Fwd: Presby Permitting???

Ch 25 Public Notice Comments for 6-14-13 WWAB Meeting 122
Hot Springs County Planning Office
415 Arapahoe, Thermopolis WY 82443
307-864-2961
hscplanner@hscounty.com

Infiltrator Systems Inc. (Infiltrator) appreciates the opportunity to make comment on the proposed revisions to the Water Quality Rules and Regulations, Chapter 25, Small Wastewater Systems.

SK1975

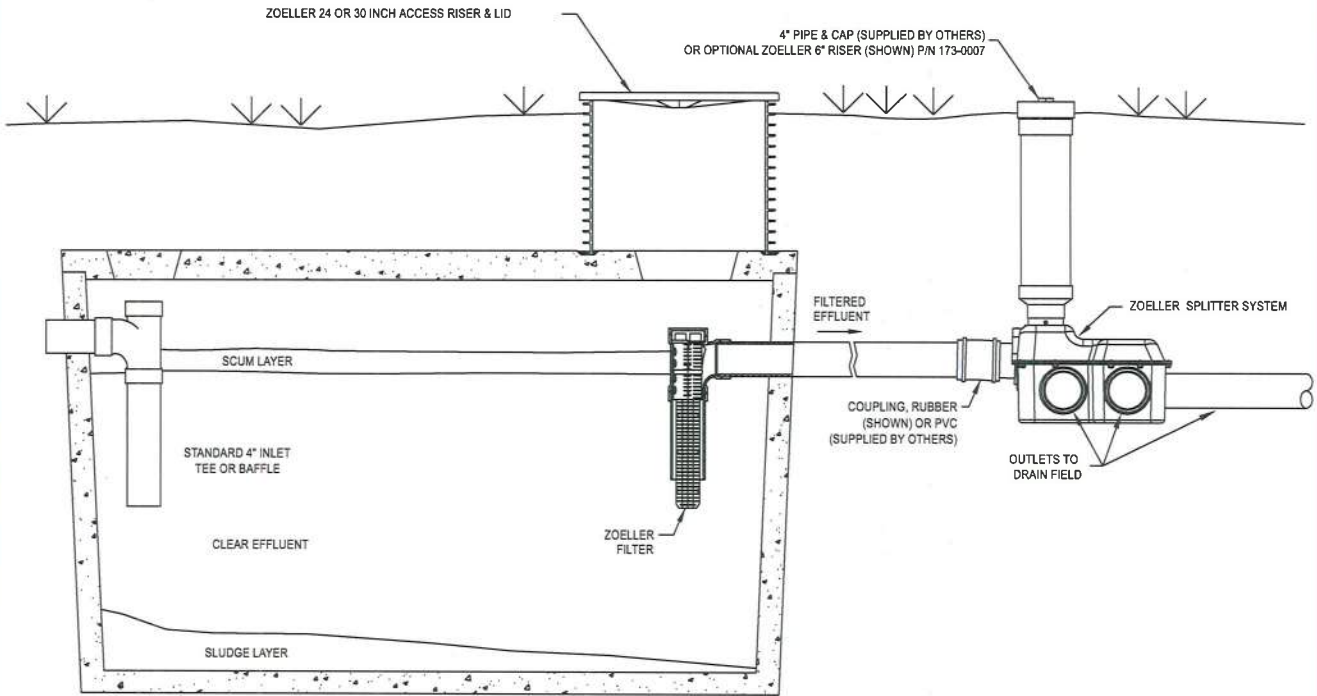
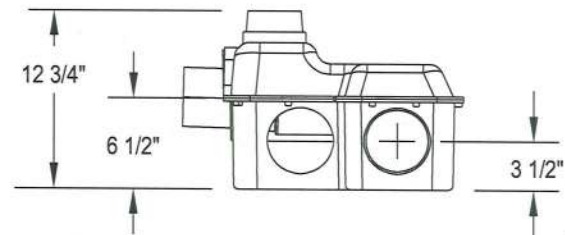
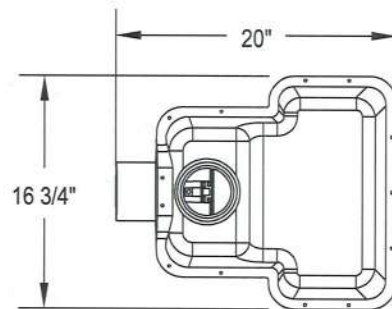
Bill I have added my comments to your draft regulations. The comments will open automatically as you get to the page they are on. Also I have attached the specification sheet for the Zoller/Clarus d-box so you can see that the use of flow equalizers is redundant with this box which we see frequently in Fremont County. I do appreciate the simplified language in the draft and think it will help contractors be more willing to read the document. If you have any questions just let me know.
